St. Johns Church Hall
Hallowell Road
Northwood

PLANNING APPLICATION

INTERNAL ALTERATIONS
PROPOSED GROUND FLOOR

Drawn By	LL	Date	Dec 2023
Checked By	JS	Date	04.12.24
Approved By	JS	Scale	100 / 50 @A1
Drawing No.		Rev.	
5530-PL-103			B

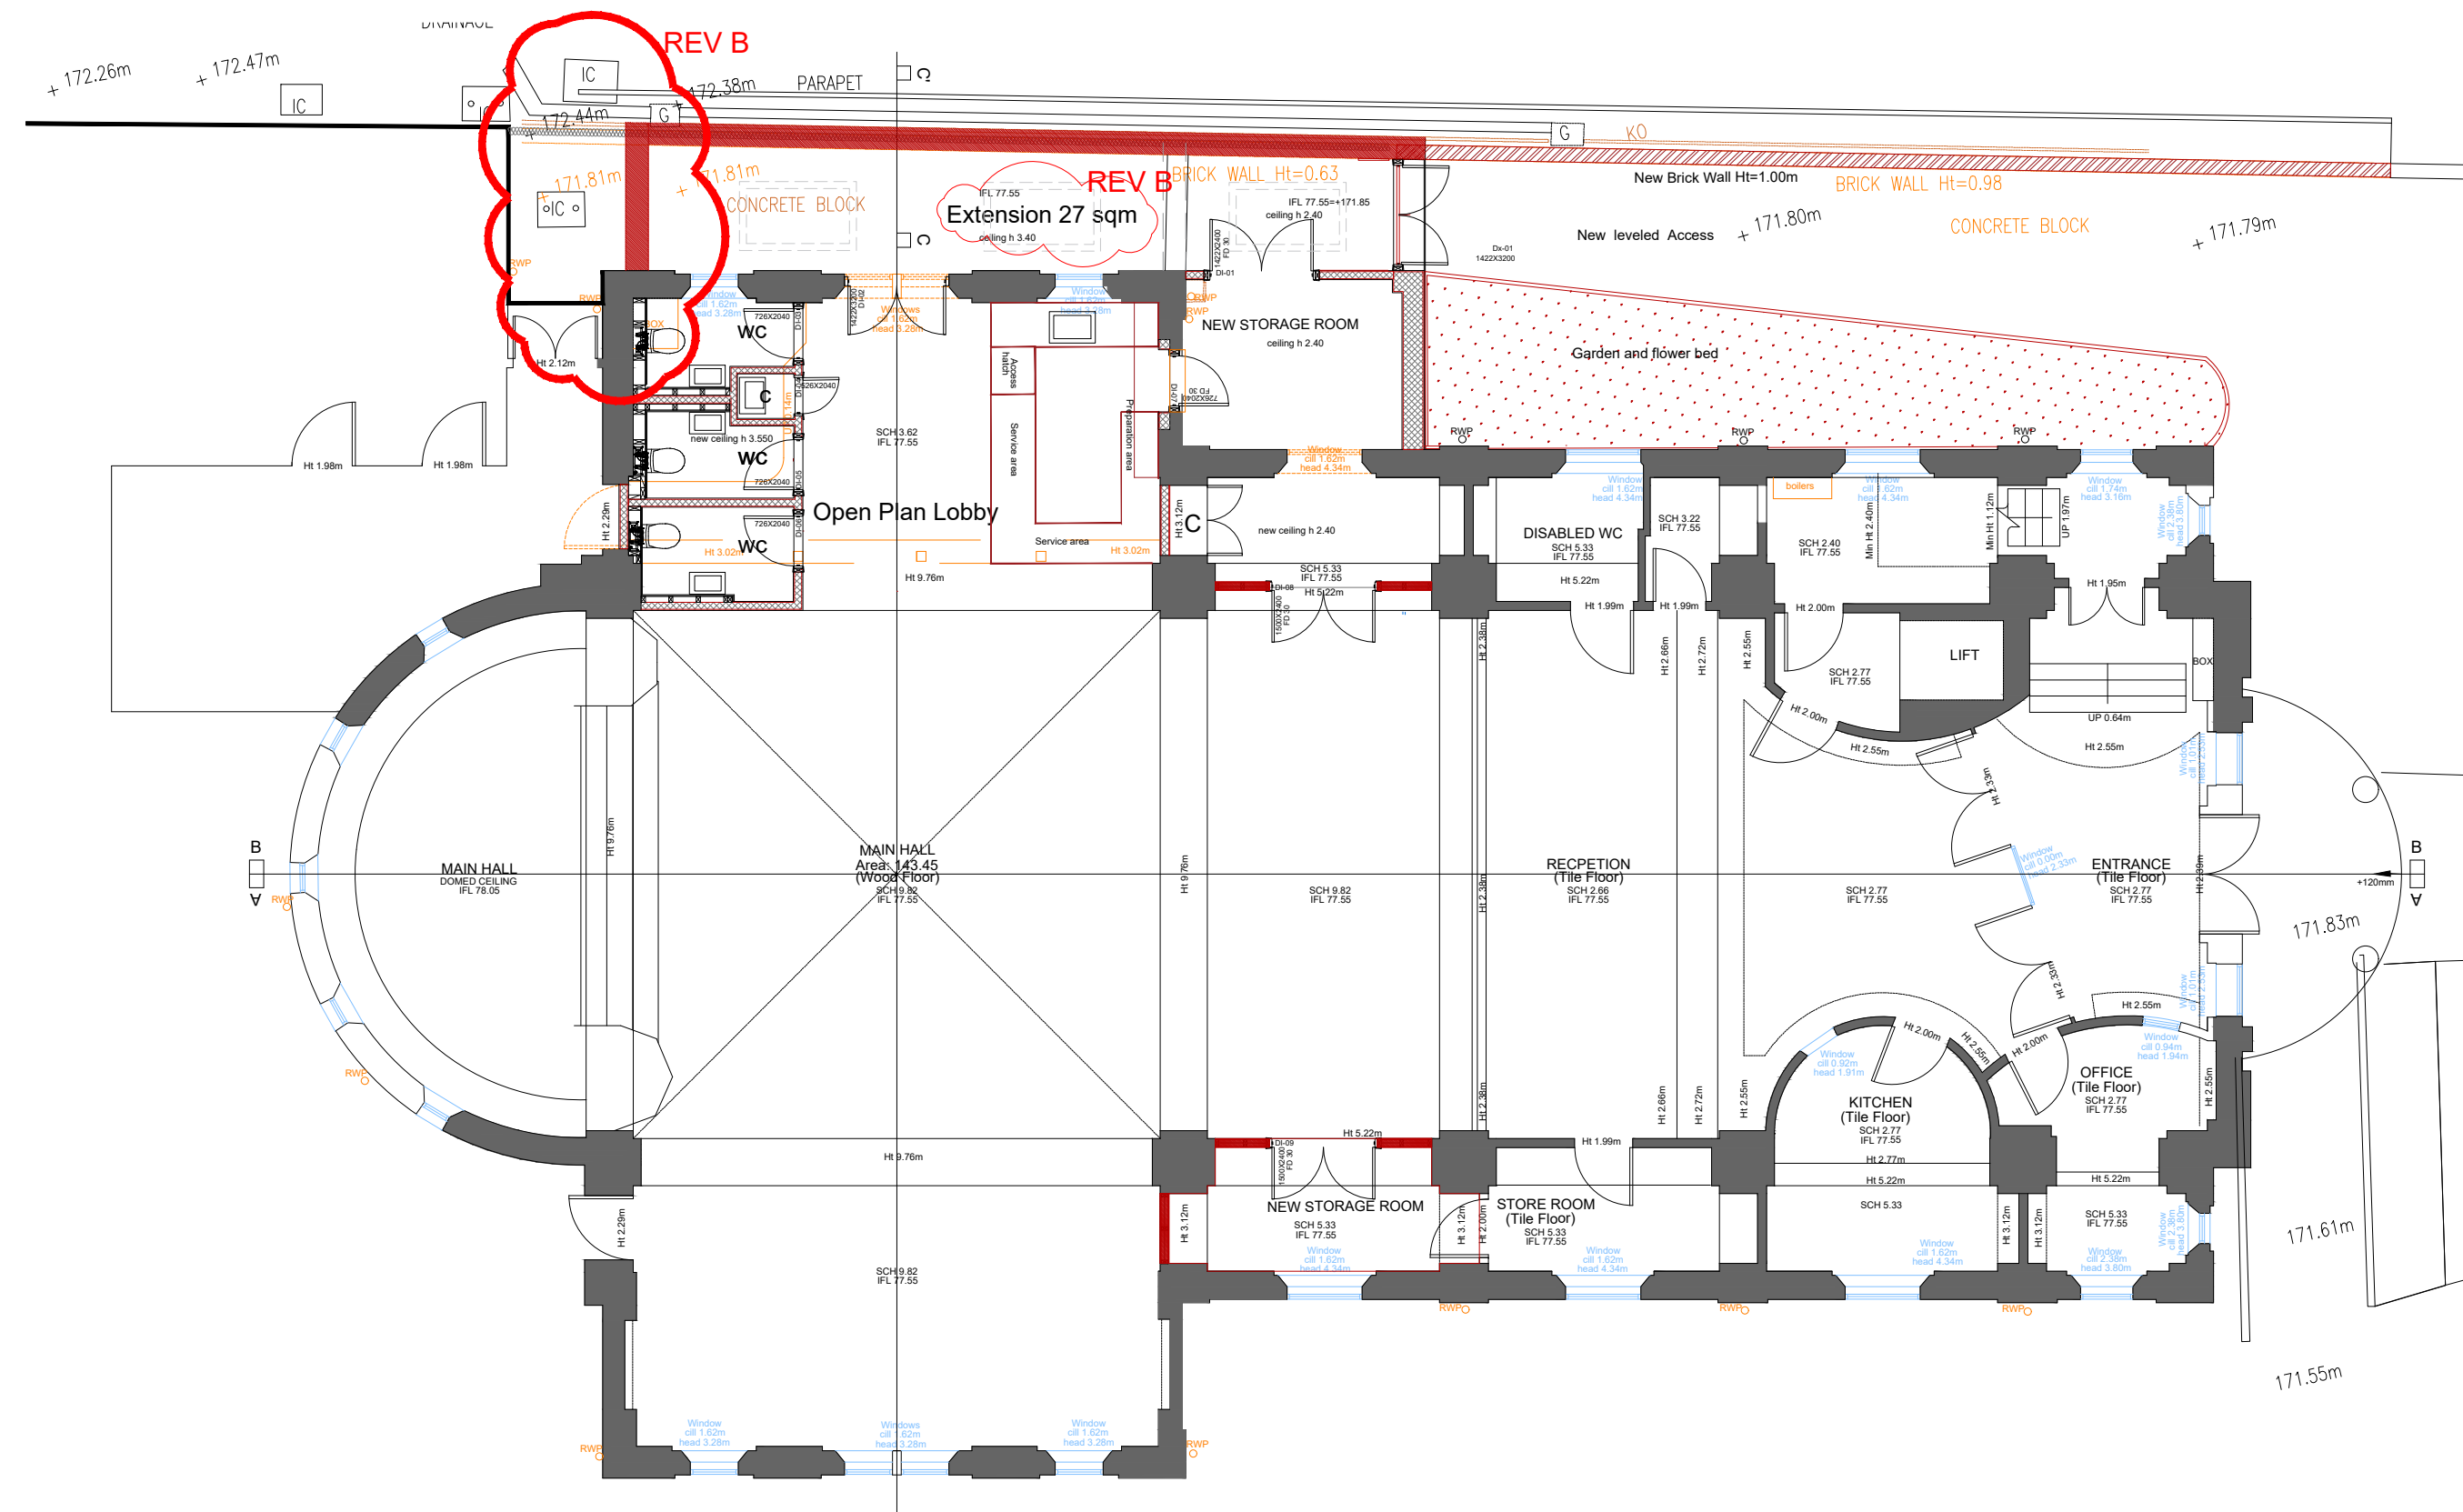
Amendments/Notes			
Rev.	Detail	By	Date
A	Planner's comments 14.08.24 Reduce length and roof height on the front part of the extension .	LL	15.08.2024
B	Section 73-variation of condition #2 Due to Thames Water constraints Reduced the extension length, added a door at the opposite end, and left the existing public manhole near the rear building outside the new extension.	LL	04.12.2024
